RE: **Palen Solar Power Project, Docket No. 09-AFC-7**
Responses to January 14, 2010 CEC Workshop Queries
Technical Areas:
Soil & Water Resources (supplemental data for DR-S&W-242)

Palen Solar Power Project

Soil and Water Data Responses to January 14, 2010 CEC Workshop Queries

DR#242 Supplemental---Soil and Water:

30% Conceptual Engineering Plans
NOT FOR CONSTRUCTION
DATED: January 28, 2010

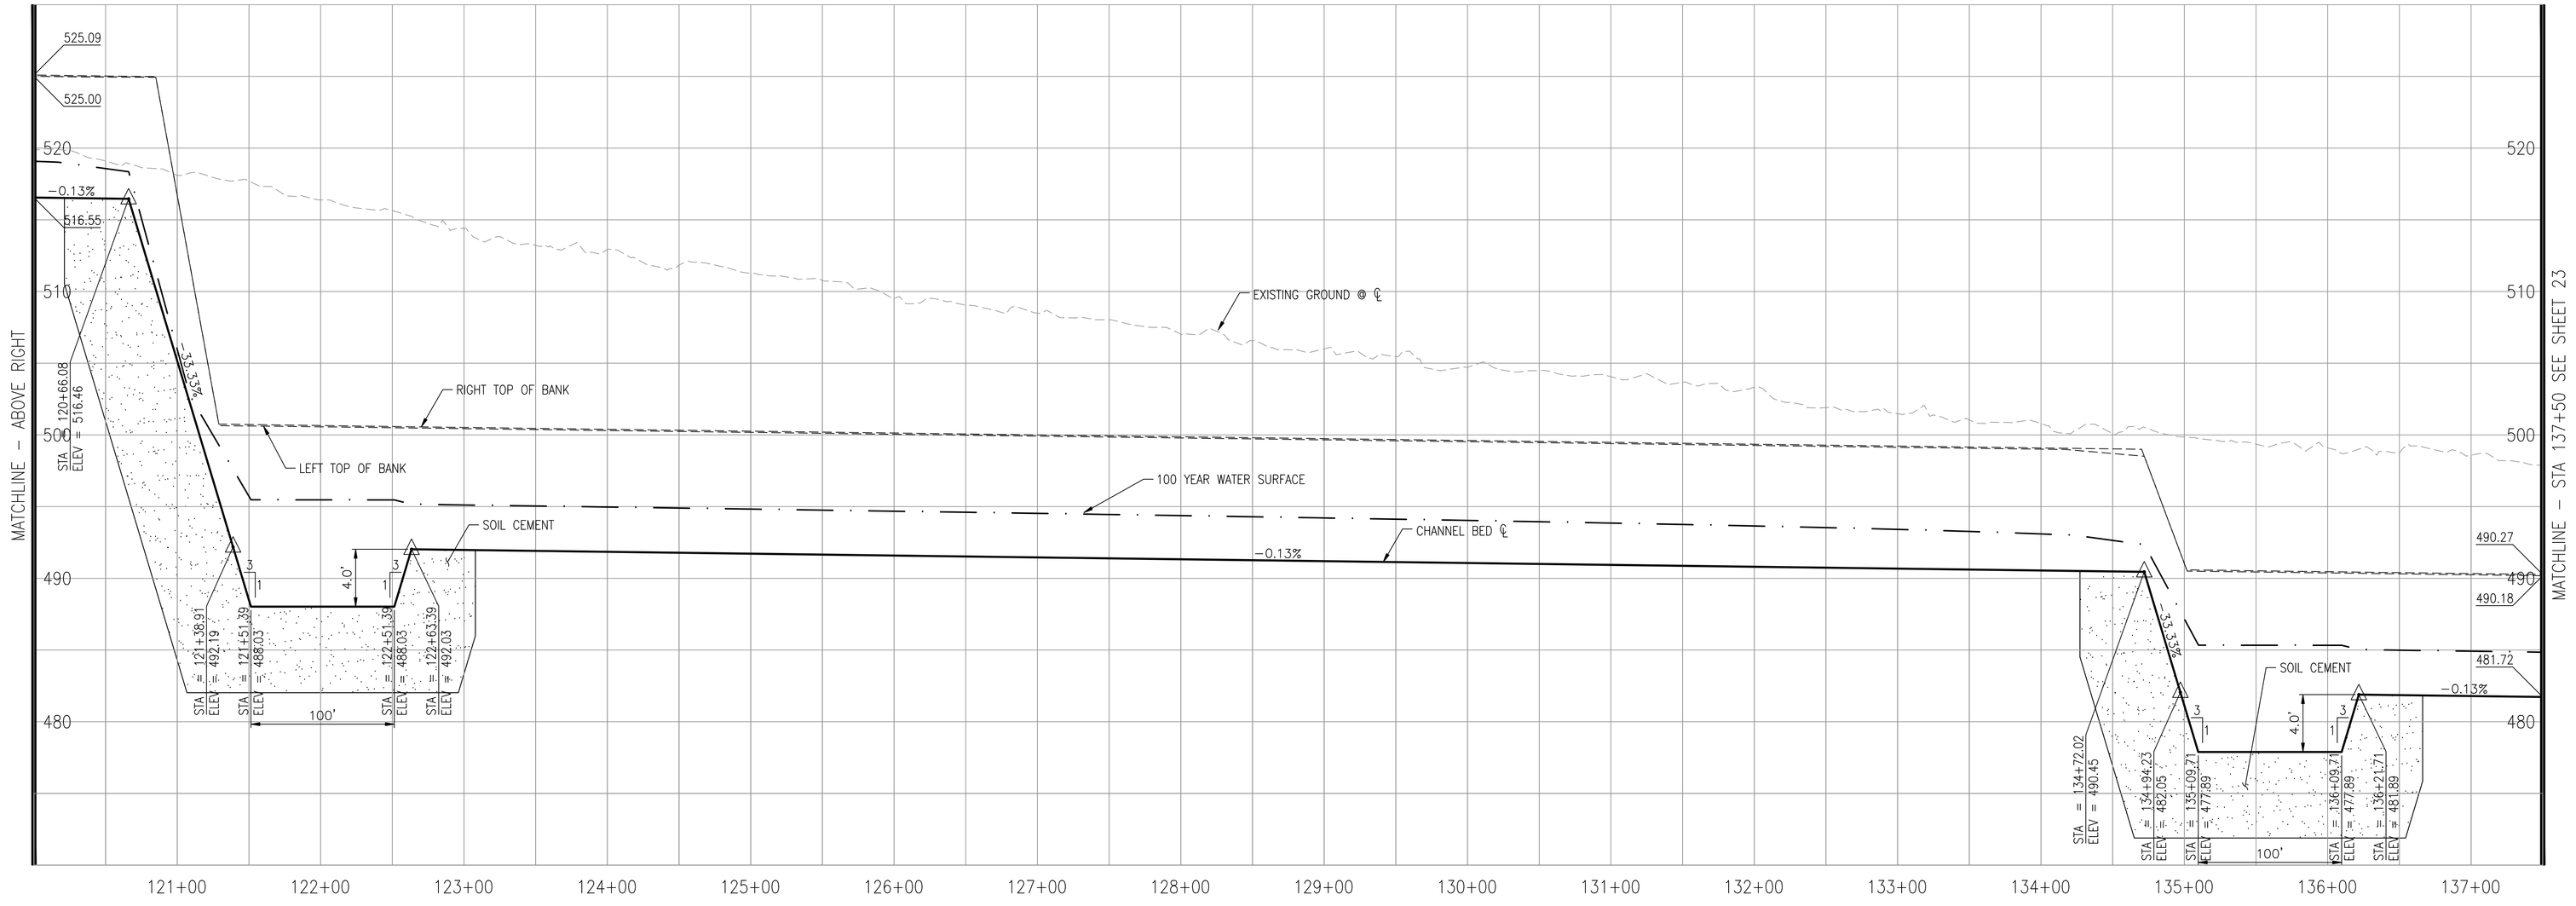
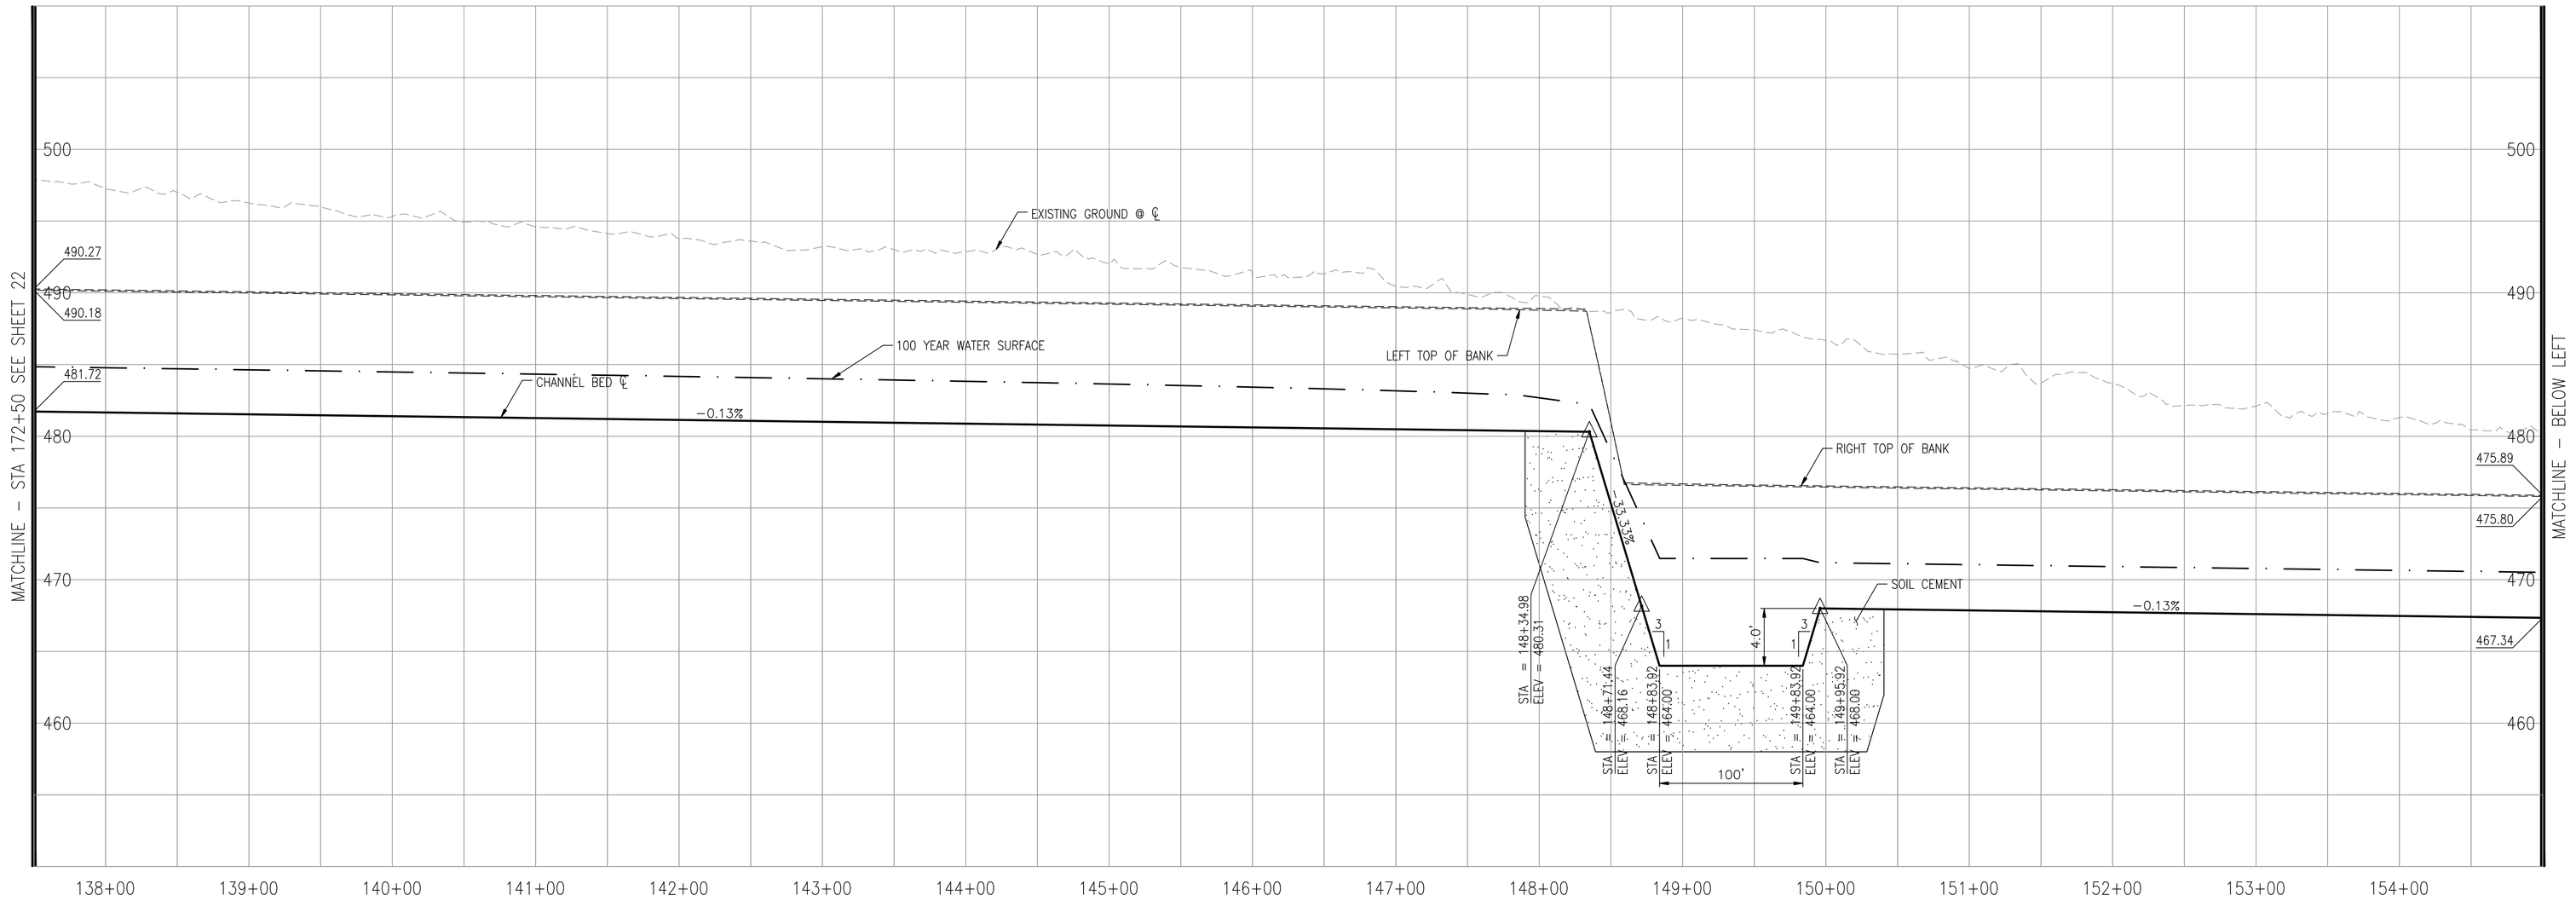
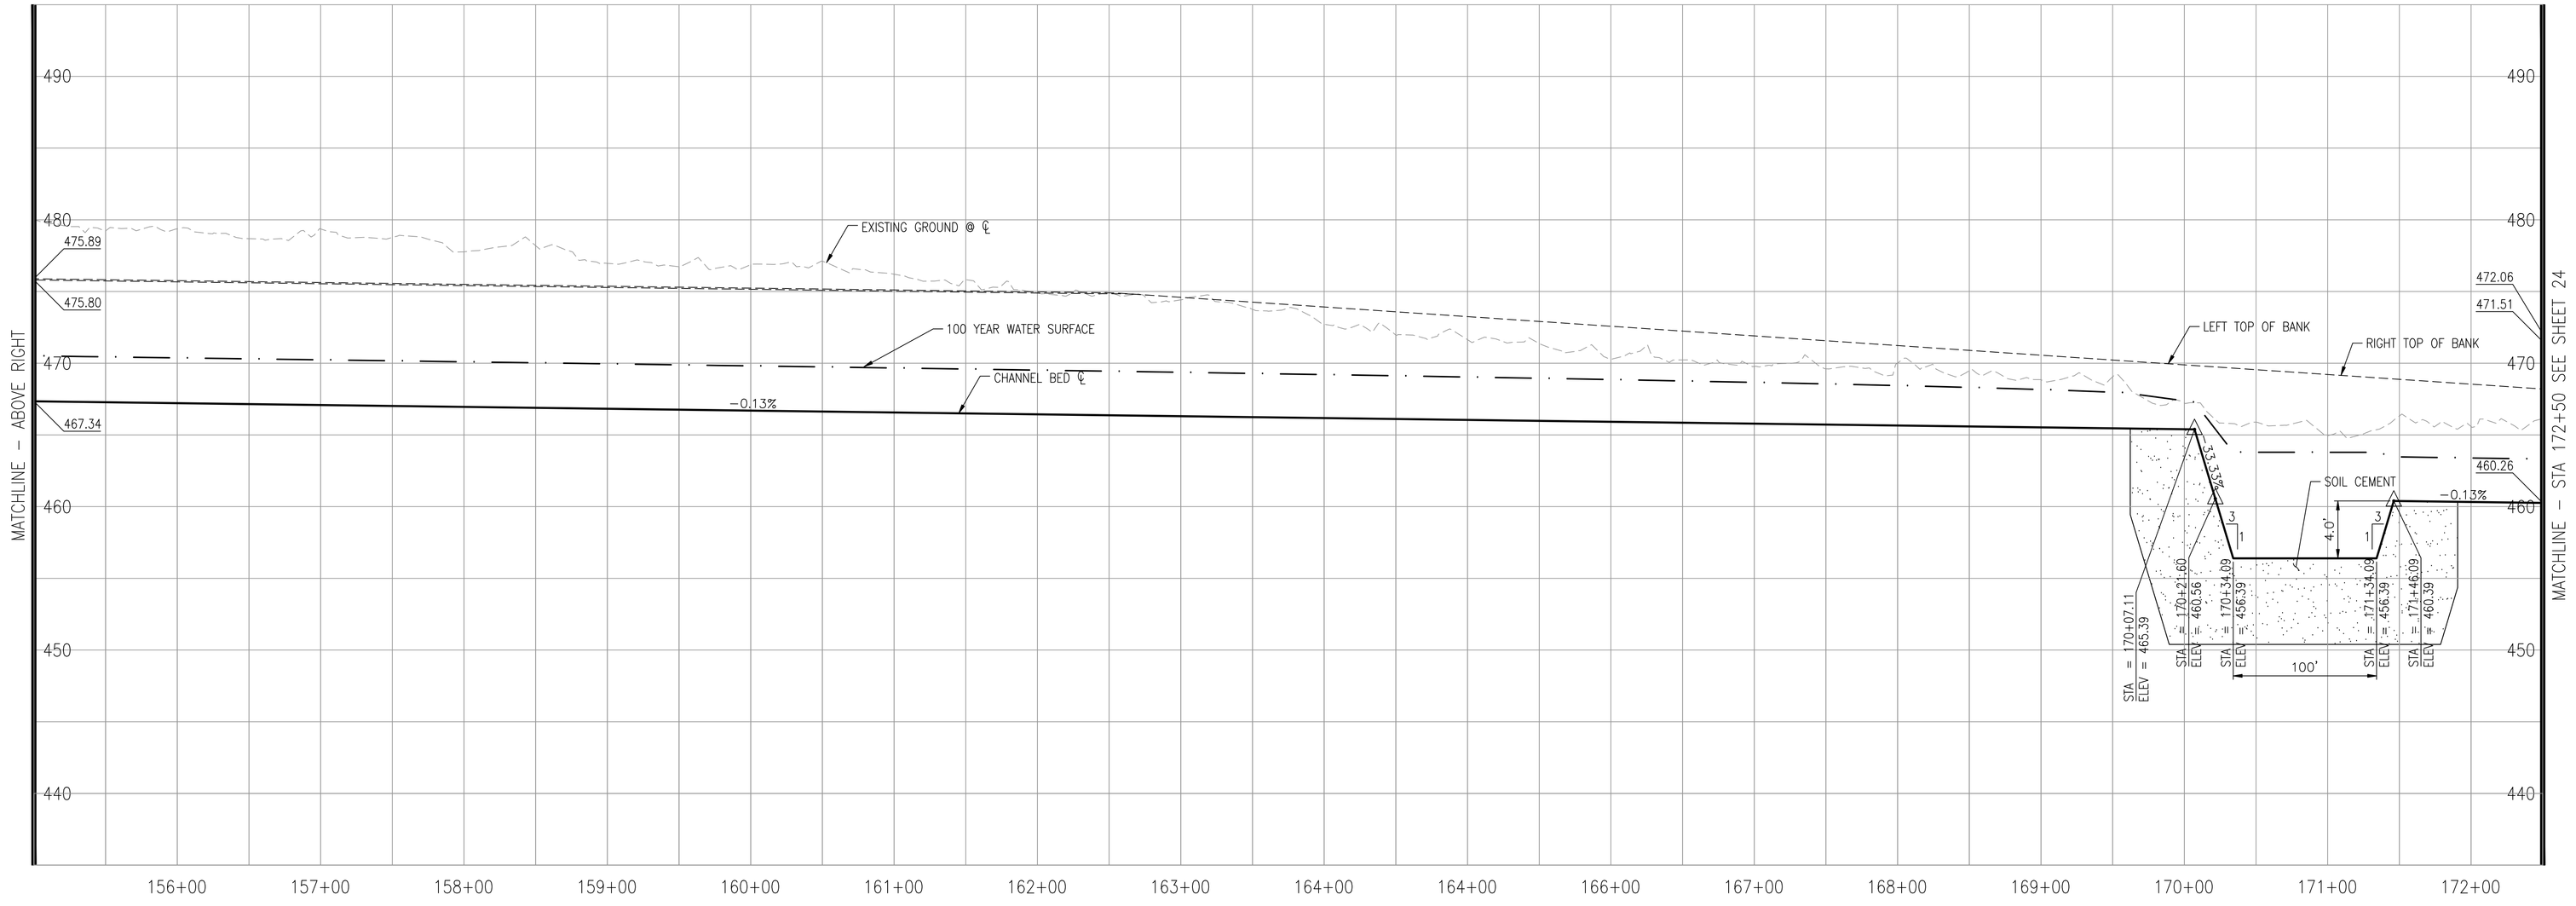
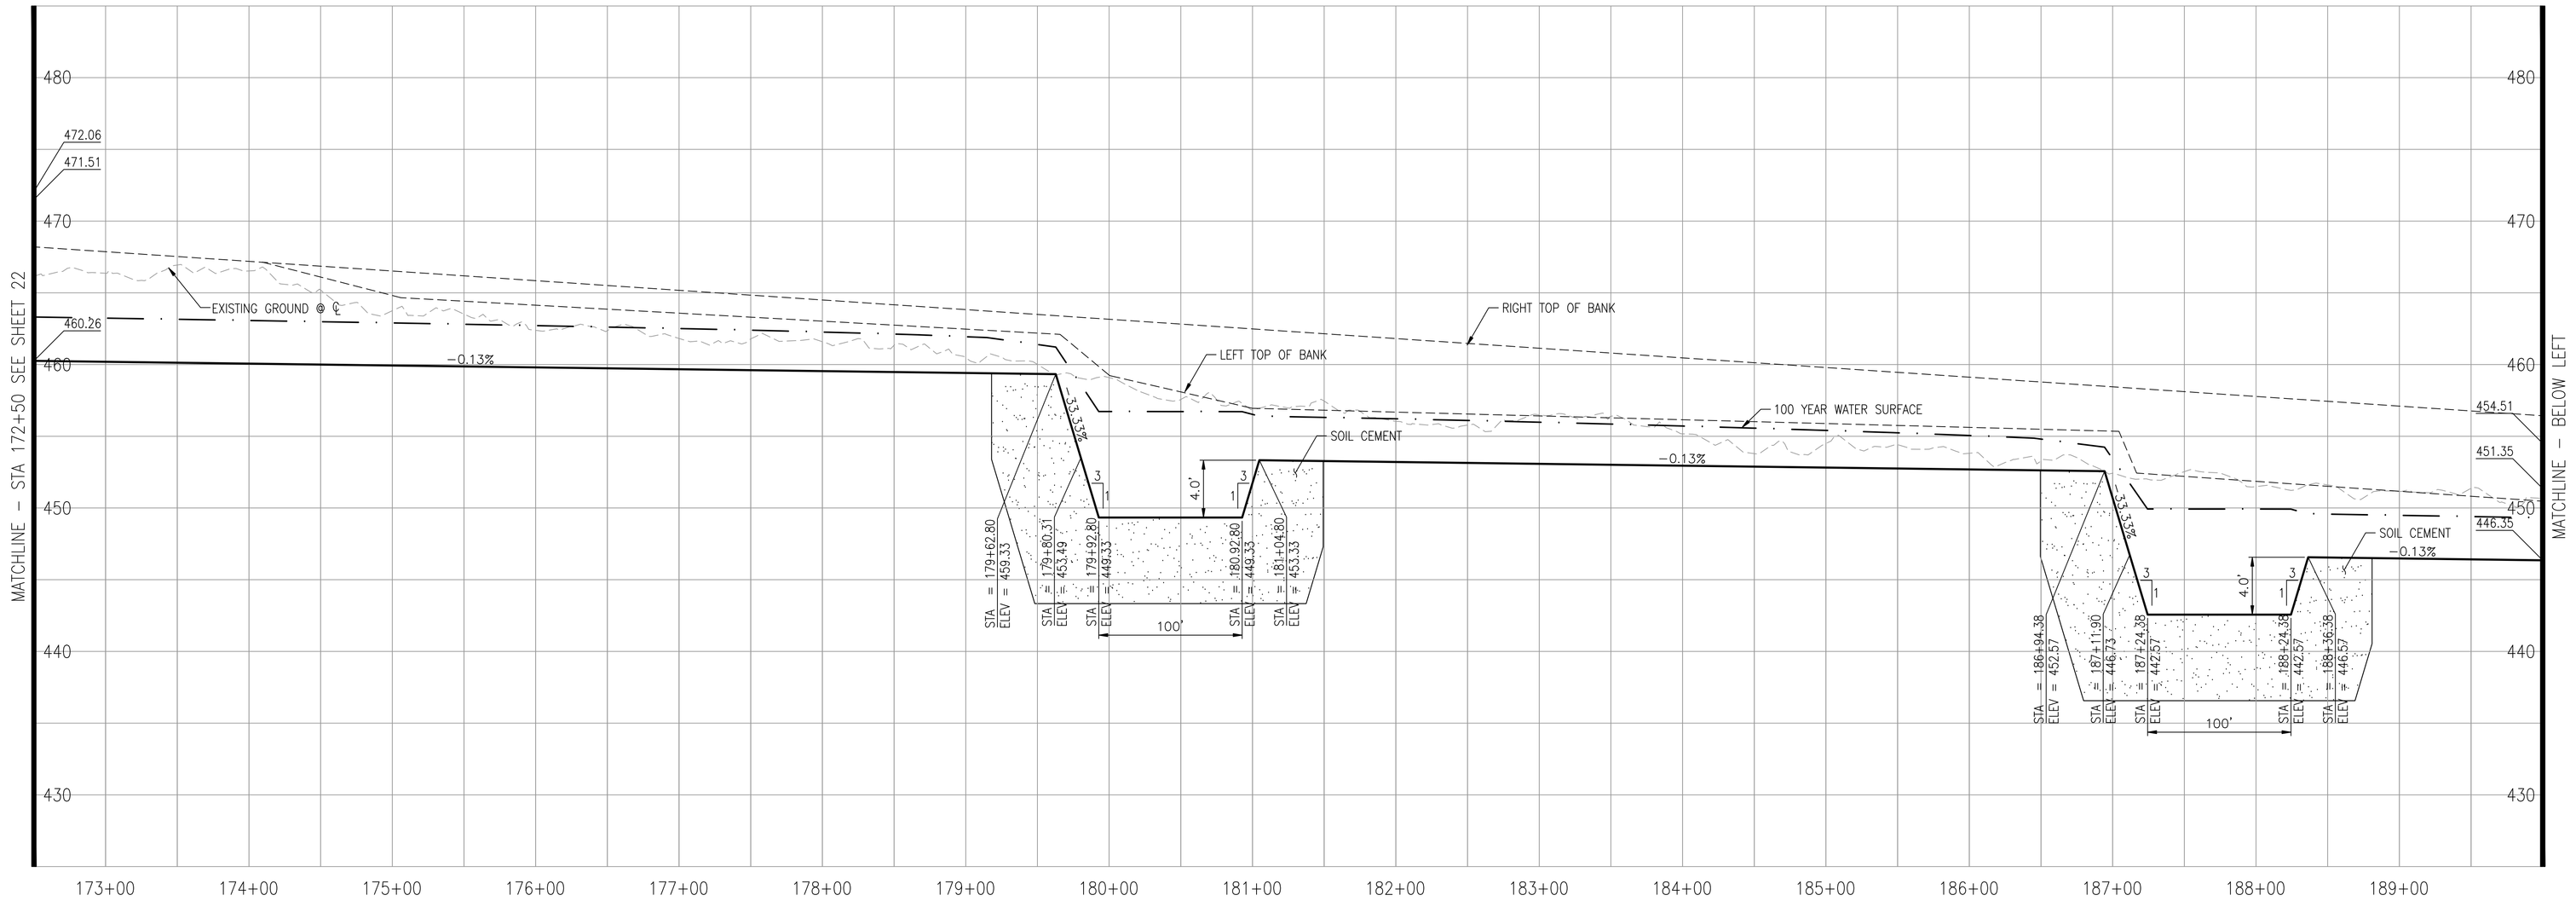
Add 100-yr. water surface elevations on profiles for main channels (both collectors and conveyance).

The 100-year water surface profile has been added to the plans and is provided as part of this response.
